Entergy Operations, Inc.

2CAN110002

Arkansas Nuclear One – Unit 2  
Docket No. 50-368  
License No. NPF-6  
Technical Specification Change Request for the Boric Acid Makeup Tank

## **DESCRIPTION OF PROPOSED CHANGES**

Figure 3.1-1

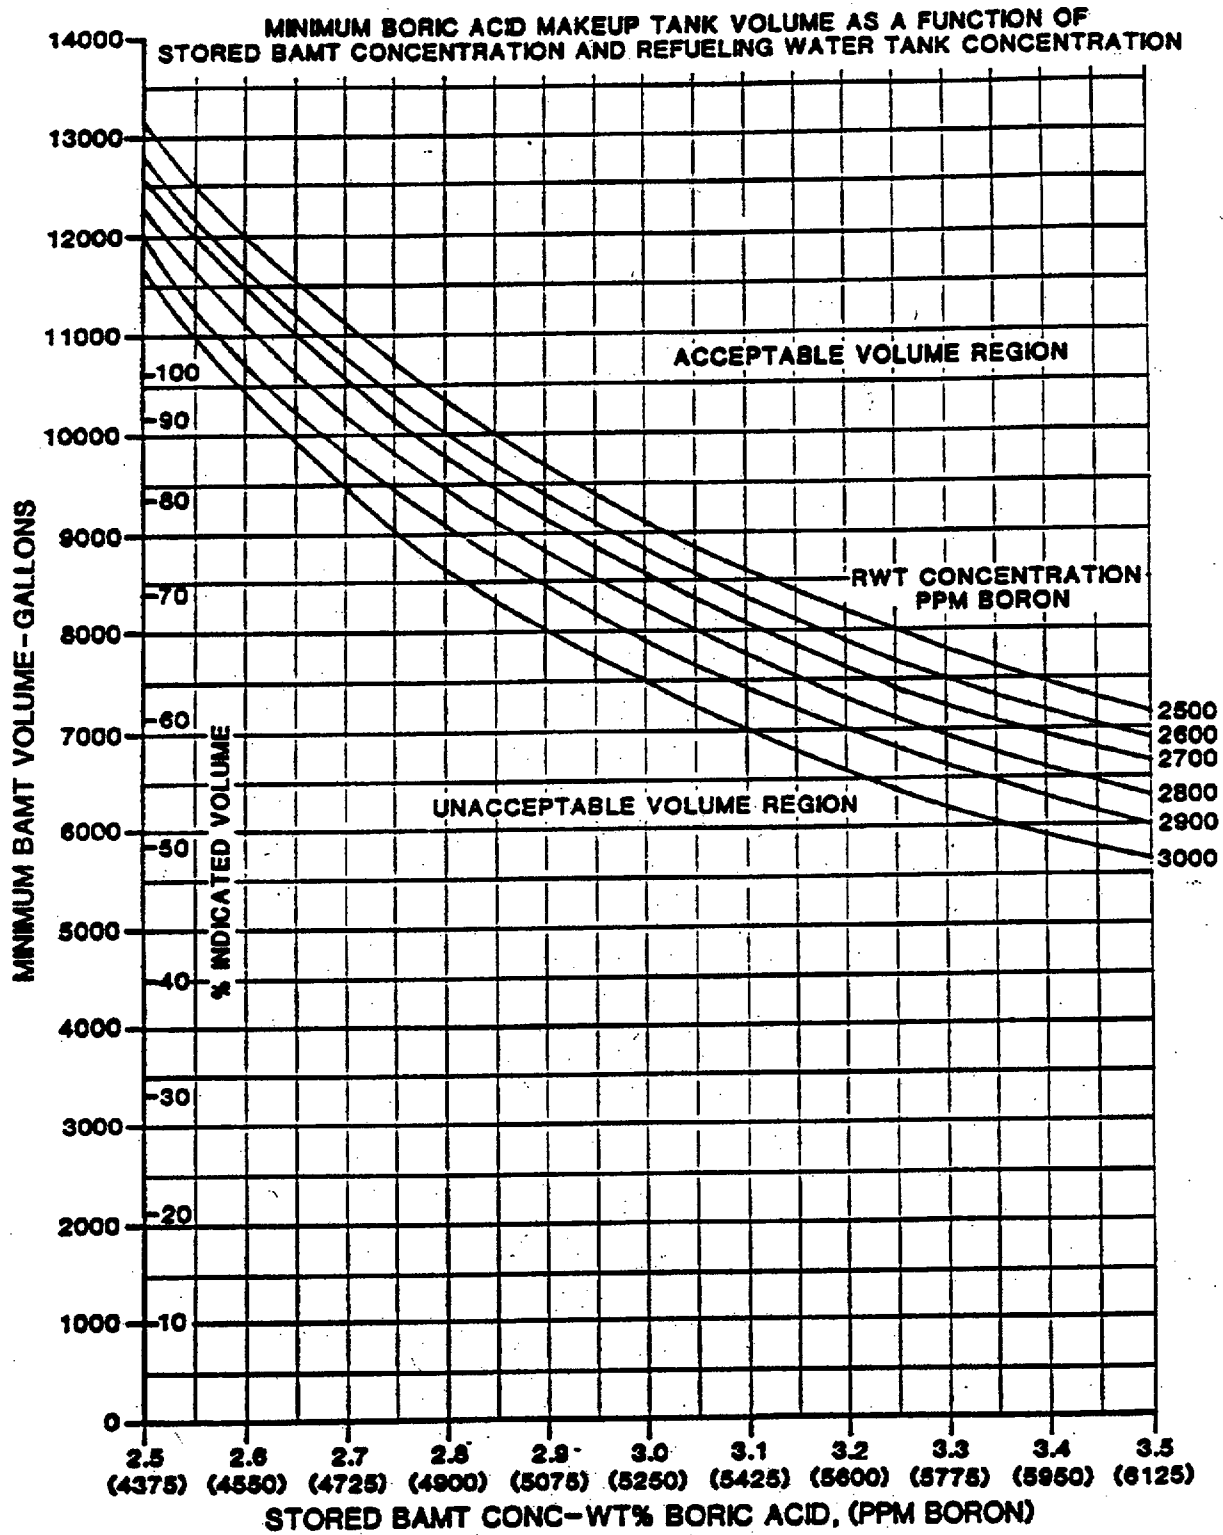
This change proposes that the boration systems contained in TS Section 3/4.1.2, with their Limiting Condition for Operation, associated Actions, Surveillance Requirements, Figures, and Bases be relocated to the Technical Requirements Manual (TRM). No change to these specifications other than the relocation is proposed in this request.

Energy Operations, Inc. is proposing that the Arkansas Nuclear One, Unit 2 (ANO-2) Operating License be amended to remove Technical Specifications (TS) 3.1.2.1, 3.1.2.2, 3.1.2.3, 3.1.2.4, 3.1.2.5, 3.1.2.6, 3.1.2.7, 3.1.2.8, and Figure 3.1-1 from the ANO-2 TS and relocate them to the ANO-2 Technical Requirements Manual (TRM).
